**Hartcliff Road, Penistone
Proposed Residential Development
Designers Response to Stage 1 Road Safety
Audit for the Proposed Highway Works
At Hartcliff Road/Chapel Lane**

August 2014 (Initial Issue)

PROPOSED HIGHWAY WORKS
FOR DEVELOPMENT AT HARTCLIFF ROAD / CHAPEL LANE, PENISTONE
14088 / August 2014

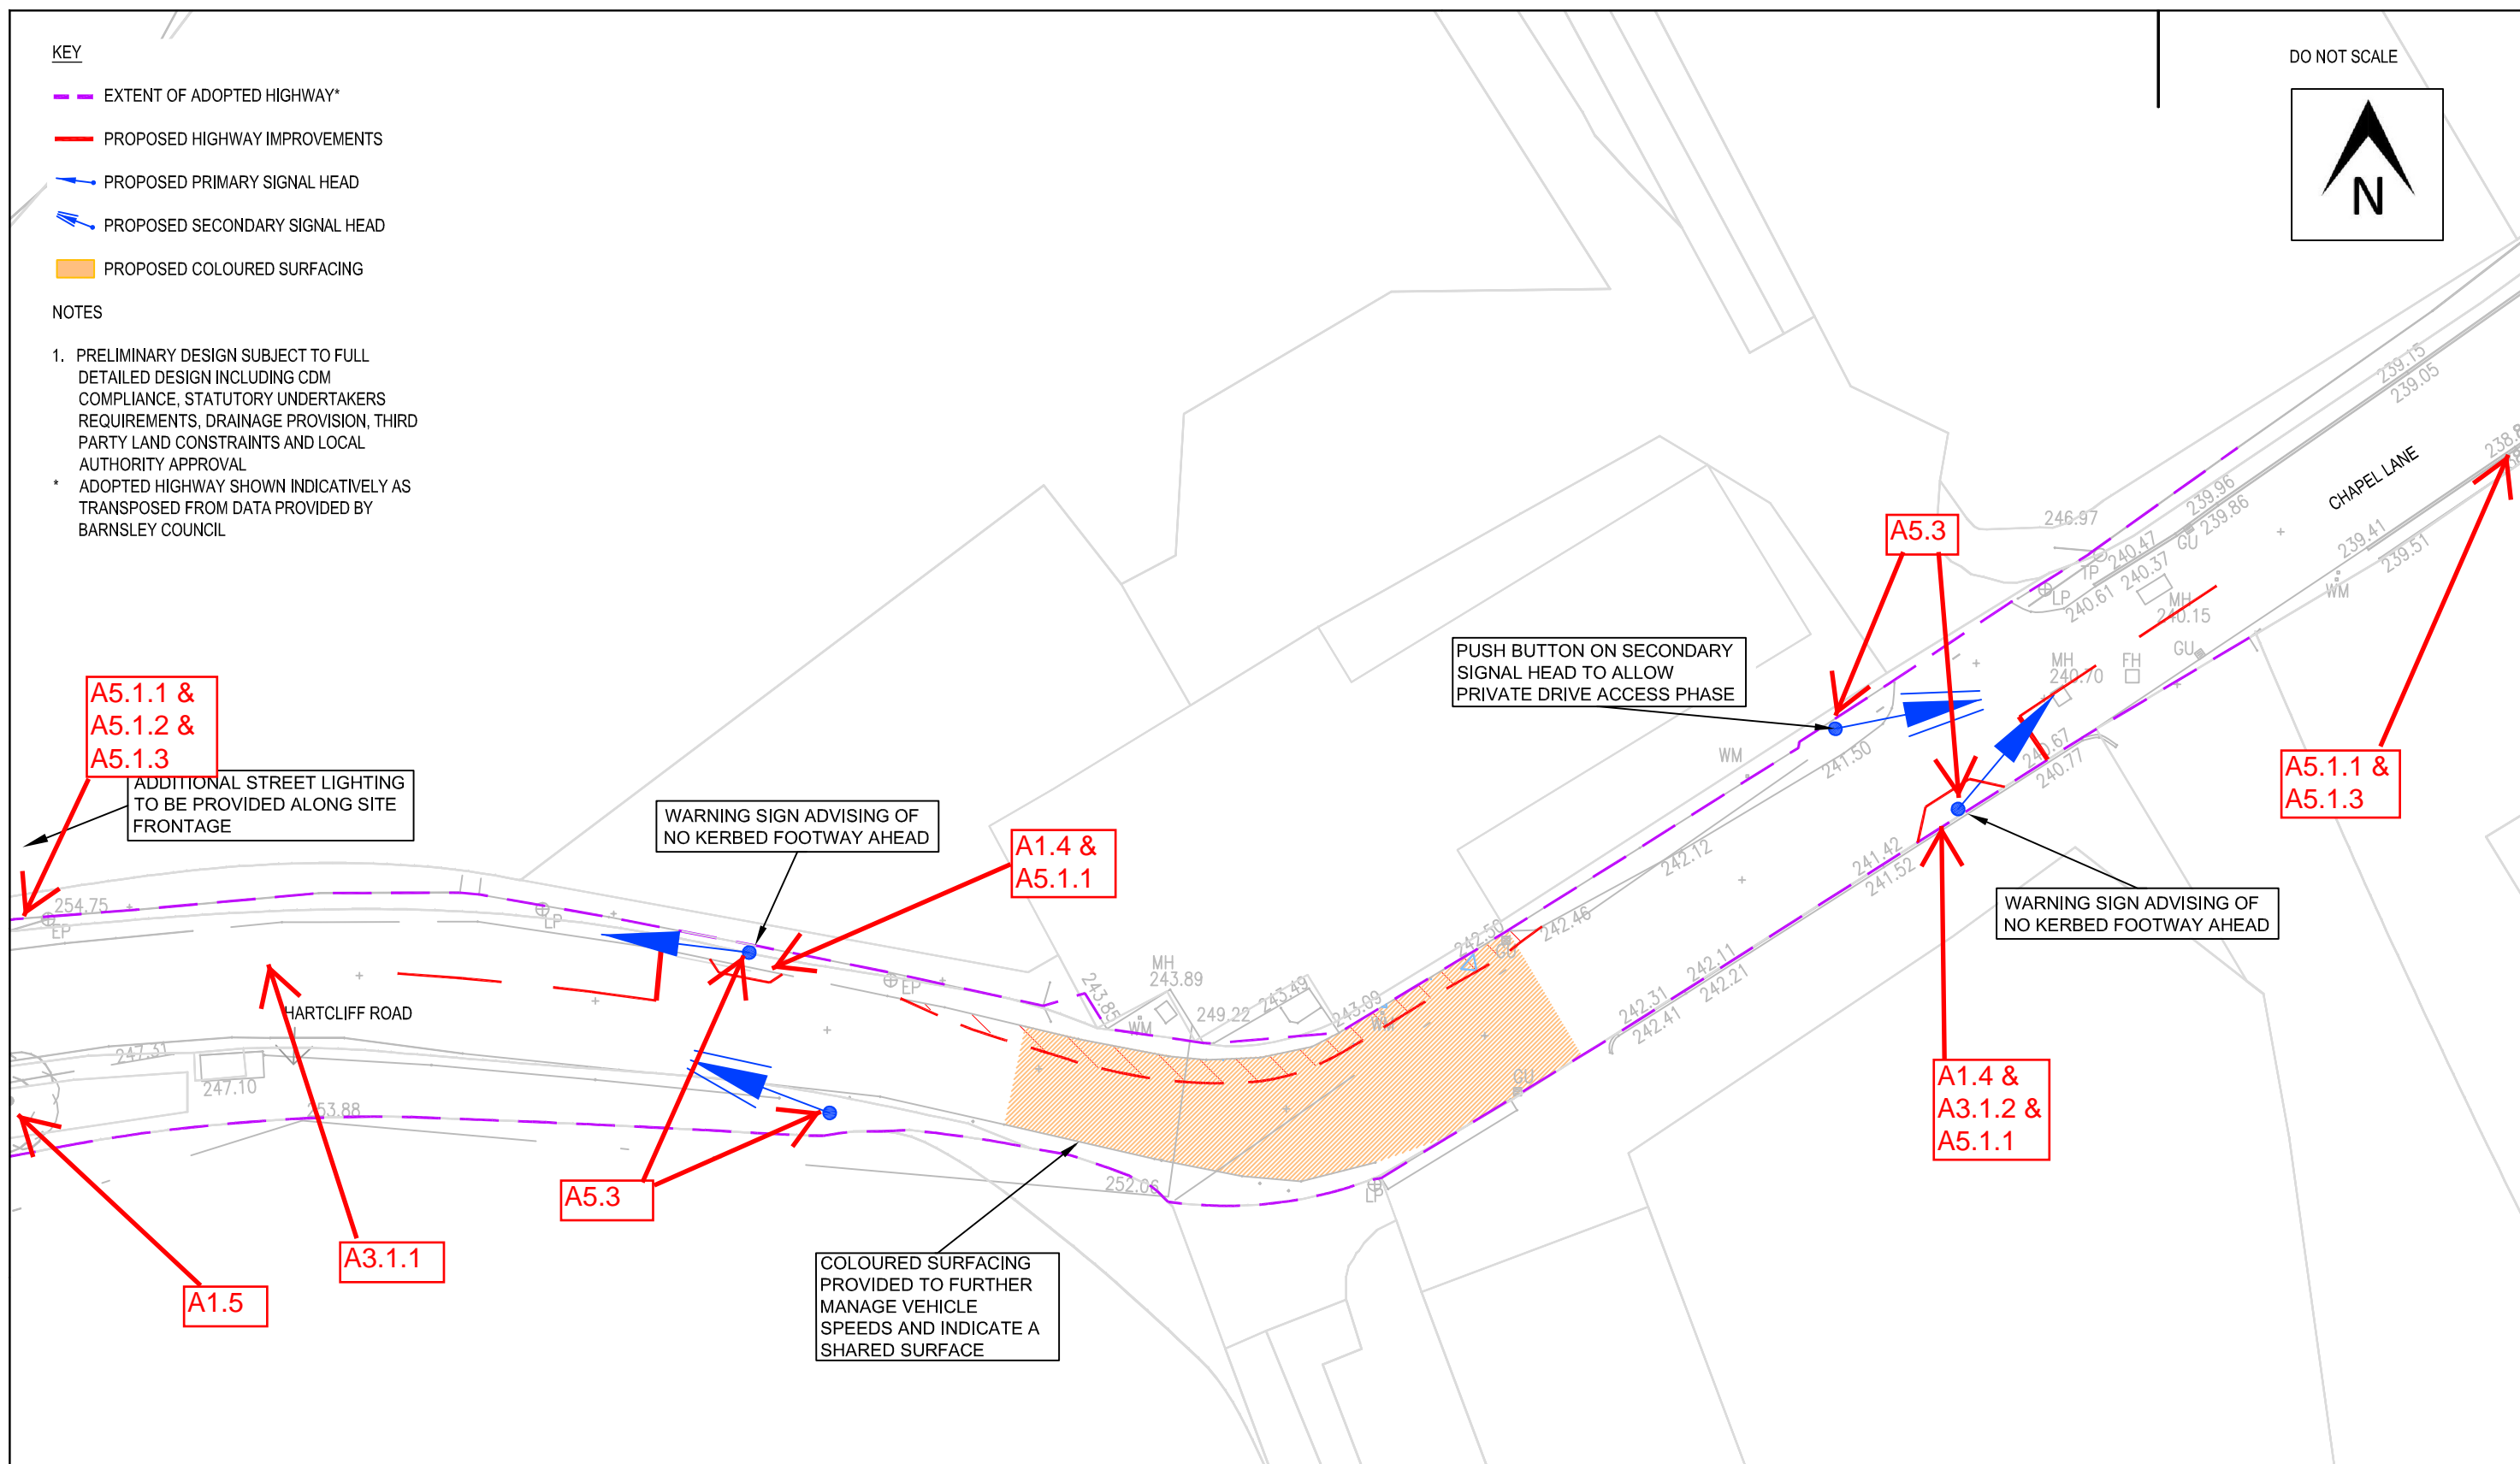
Summary: *The proposed build outs to accommodate the signal heads obstruct the free passage of surface water to the adjacent gullies which could result in ponding.*

In order to accommodate the new primary signal heads it is proposed to locate them adjacent to build outs in the existing kerb line to protect them from accidental vehicle collision. It is unclear from the information provided to the Audit Team as to how surface water will be able to flow past these features and allow the carriageway to drain properly.

Summary: *The proposed build out is close to a private drive serving several properties. Vehicles using this drive may be obstructed by the new feature and mount the footway placing pedestrians at risk.*

The proposed build out on the Chapel Lane approach to the signals is located almost opposite a private drive serving several residential properties. Whilst some vehicle swept path information was provided to the Audit Team for a vehicle turning left in to the drive this appears to be very tight with no margin for driver error and there was no swept path shown for a vehicle turning right out of the drive. It is therefore unclear whether a vehicle will be able to turn left in to or right out of the drive without either over running the northern footway or mounting the build out and be in conflict with pedestrians and the new signal equipment placed in these areas.

The Design Team shall carry out further swept path analyses to demonstrate how the vehicles anticipated to use the private drive will be able to do so without over running existing or proposed footway / build out areas or colliding with signal equipment.

The drawings provided to the Audit Team show these signs located on the poles for the primary traffic signal heads. As the footway provision ends some distance prior to these points and that the signs should be located in advance of the hazard their location provides inadequate warning of the potential for pedestrians to be walking in the carriageway and could lead to collisions with the same.

None of the drawings provided to the Audit Team indicate the proposed location for the traffic signal controller. A suitable location to allow safe access to the equipment should be determined and agreed with the Highway Authority.

Optima Drawing 12006-ATR-05 Rev B

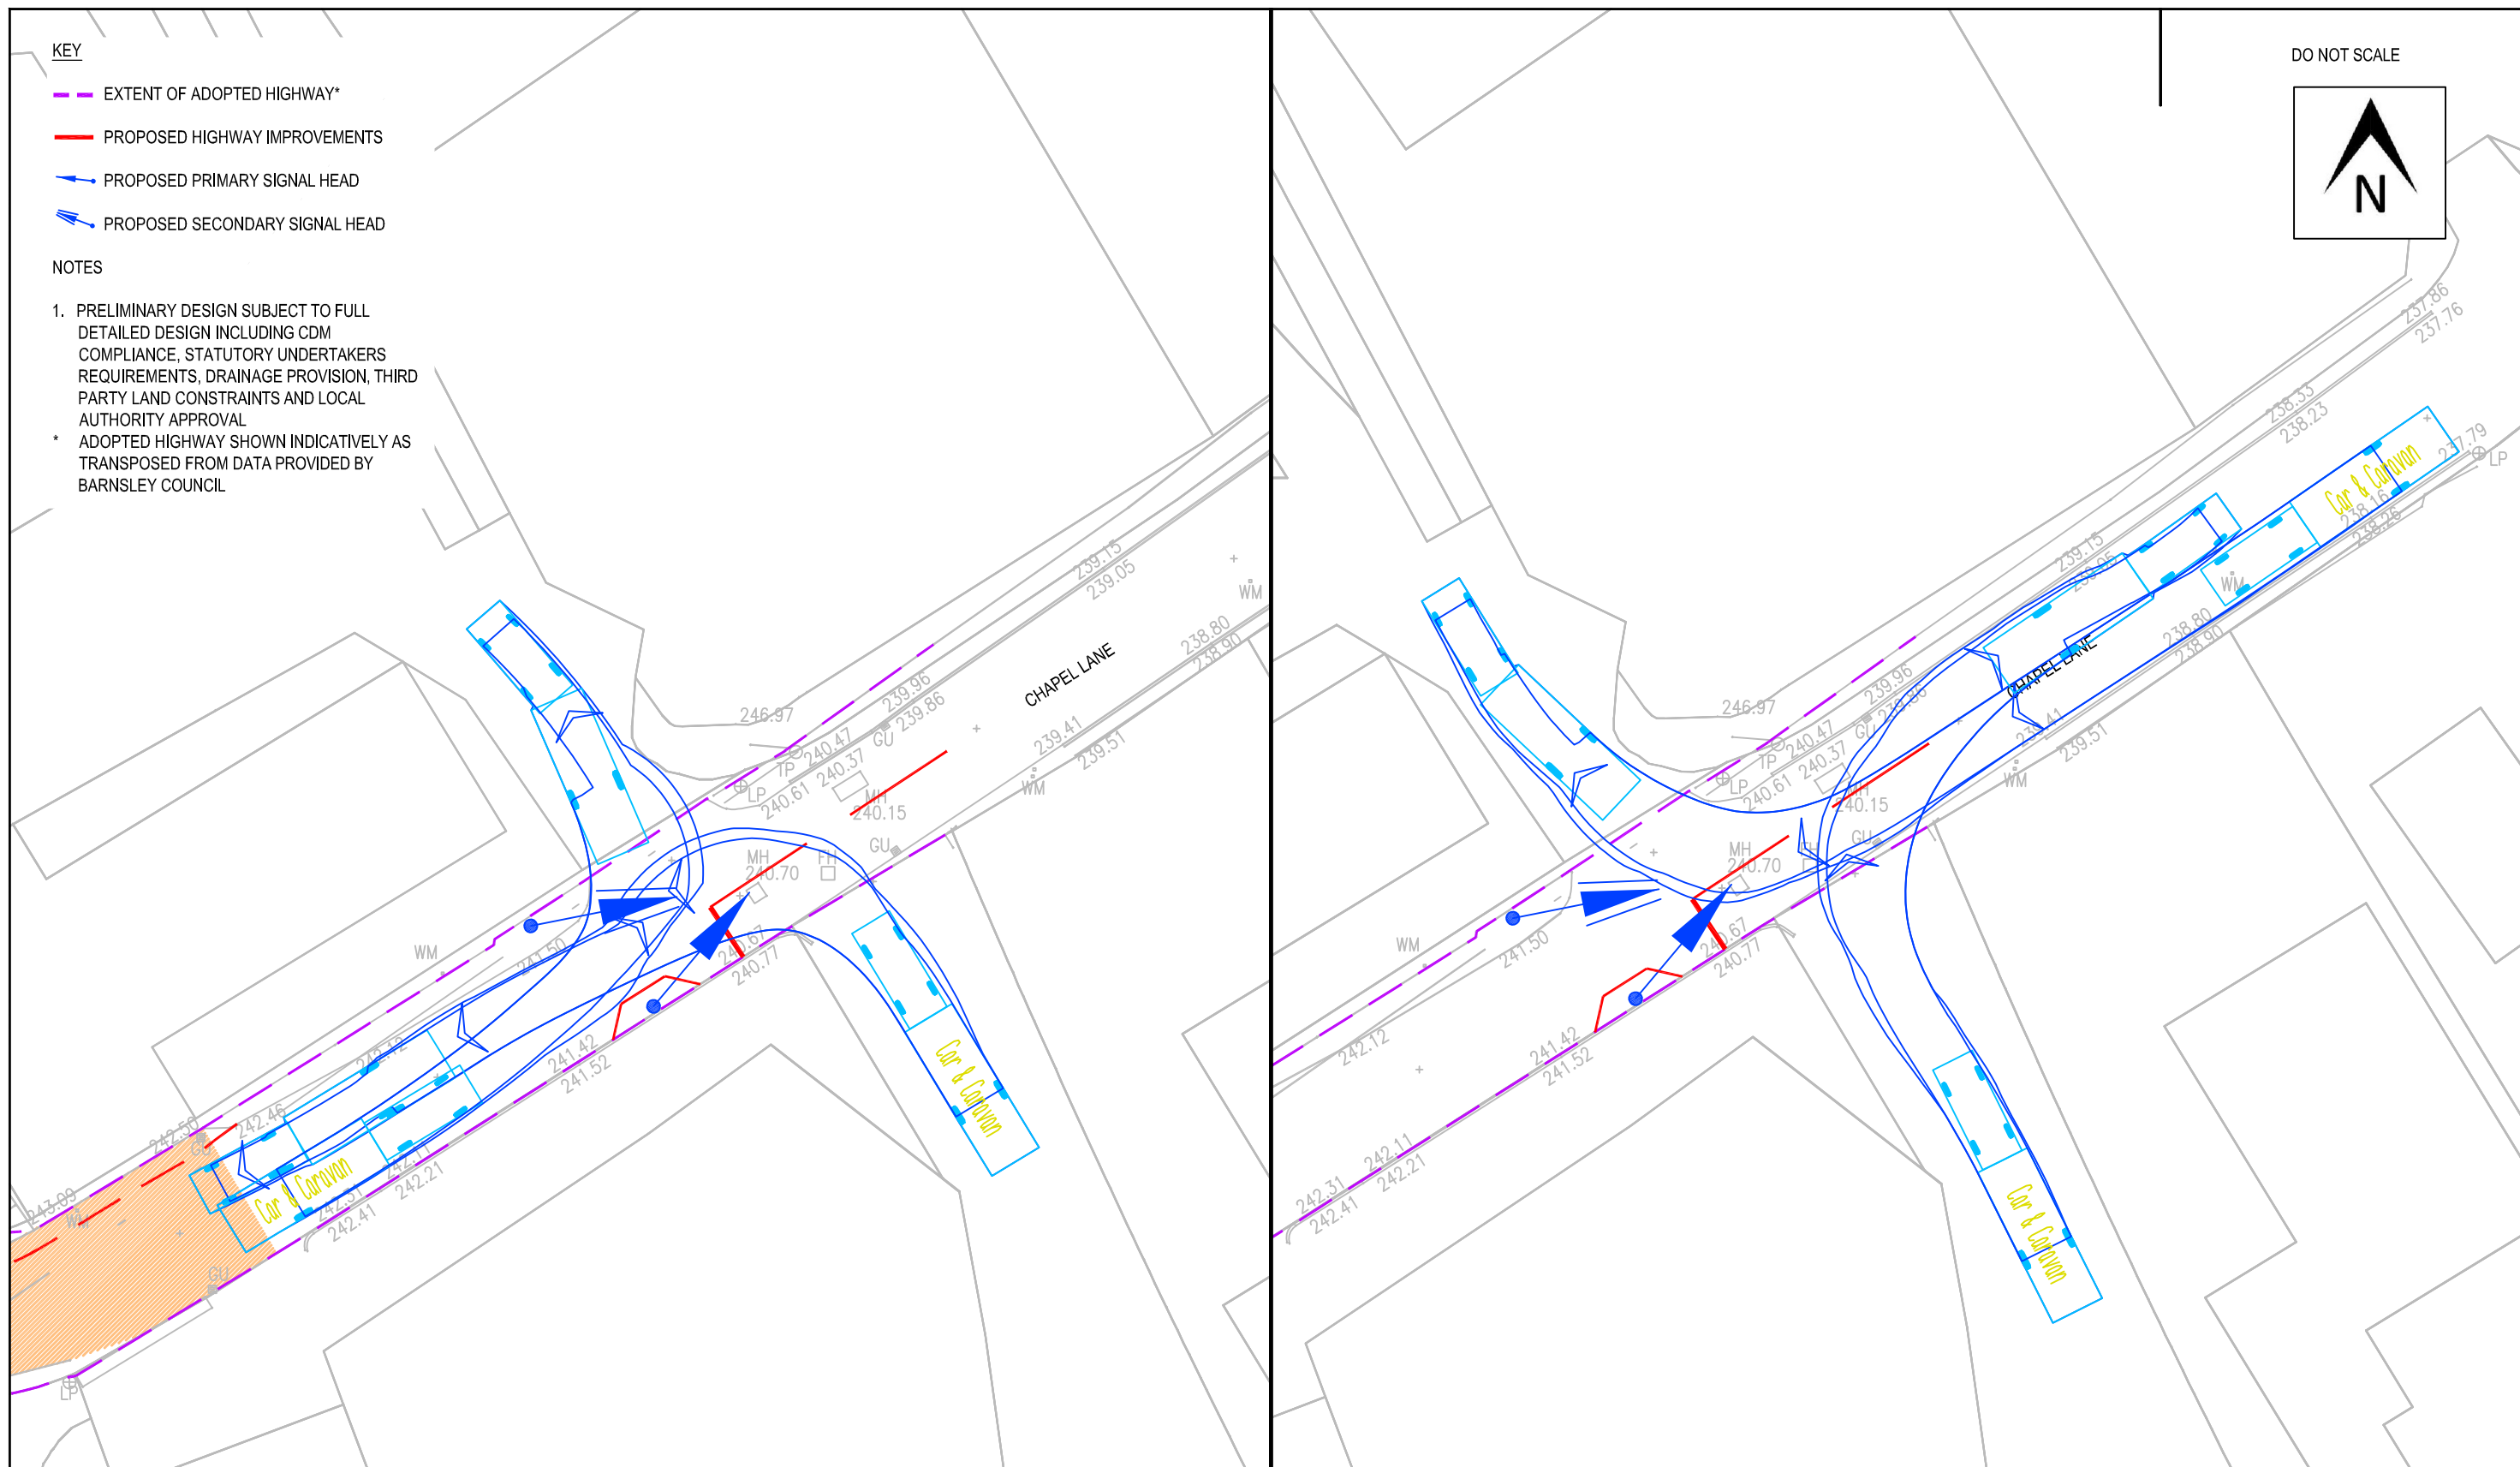
Summary: *The proposed build out is close to a private drive serving several properties. Vehicles using this drive may be obstructed by the new feature and mount the footway placing pedestrians at risk.*

The proposed build out on the Chapel Lane approach to the signals is located almost opposite a private drive serving several residential properties. Whilst some vehicle

swept path information was provided to the Audit Team for a vehicle turning left in to the drive this appears to be very tight with no margin for driver error and there was no swept path shown for a vehicle turning right out of the drive. It is therefore unclear whether a vehicle will be able to turn left in to or right out of the drive without either over running the northern footway or mounting the build out and be in conflict with pedestrians and the new signal equipment placed in these areas.

The Design Team shall carry out swept path analyses to demonstrate how the vehicles anticipated to use the private drive will be able to do so without over running existing or proposed footway / build out areas or colliding with signal equipment.

Drawing 12006-ATR-05 Rev B attached in Appendix B illustrates a swept path analysis including all manoeuvres. The swept path analysis confirms that the largest expected vehicle (car and caravan) can be accommodated accessing and egressing the private residential dwellings. Notwithstanding this it should be noted that the vast majority

of traffic utilising these access points will be a private cars routing via Mortimer Road which can comfortably be accommodated.
